# **City of Minnetonka**

## **Americans with Disabilities Act**

### **Transition Plan for Public Building Facilities**

November 2024

**Photo 4:** Service counters for City Clerk, Planning / Permits / Inspections and Utility Billing & Assessing are currently at 42" AFF (vs. 36" maximum).

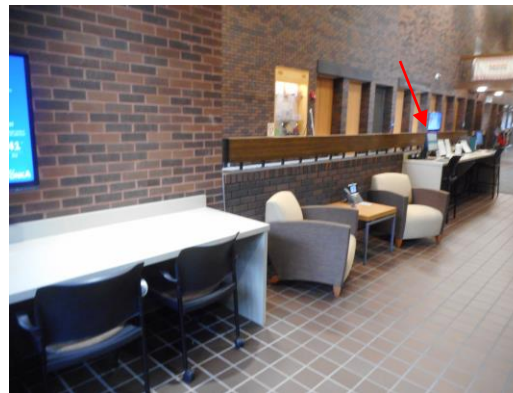
| Location<br>JQP # / Item #                               | Solution / Comments   | Qty | Unit Cost | Total Cost                | Priority       | Estimated<br>Compl. Date | Person<br>Responsible | Actual<br>Compl.<br>Date | Actual<br>Cost |
|--|---|-----|-----------|---------------------------|----------------|--------------------------|-----------------------|--------------------------|----------------|
| 21A 27774  | Lower a minimum 36" wide section of counter to a maximum height of 36" above the floor.<br>ICC ANSI 904.3<br><i>The Planning / Permits / Inspections service counter is currently at 42" AFF (vs. 36" maximum). Photo 4.</i>              | 1   | \$1,000   | \$1,000                   | 2              |                          |                       |                          |                |

**Photo 8:** The council chambers have movable seating that was arranged to integrate wheelchair seating positions. *This is a good example of accessibility.*  
Confirm the availability of an assistive listening system for this space.

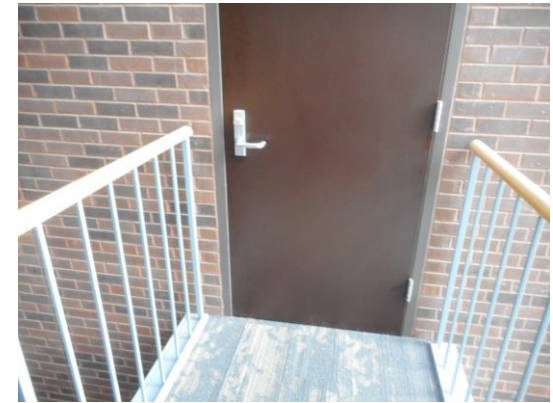
| Location                               | Solution / Comments | Qty  | Unit Cost | Total Cost | Priority | Estimated<br>Compl. Date | Person<br>Responsible | Actual<br>Compl.<br>Date | Actual<br>Cost |
|--|---------------------|--|-----------|------------|----------|--------------------------|-----------------------|--------------------------|----------------|
| 26A                                    | 27909               | Provide a permanent assistive listening system with signs indicating availability. IBC 1108.2.7<br><i>Photo 8.</i>   | 1         | \$3,000    | \$3,000  | 2                        |                       |                          |                |
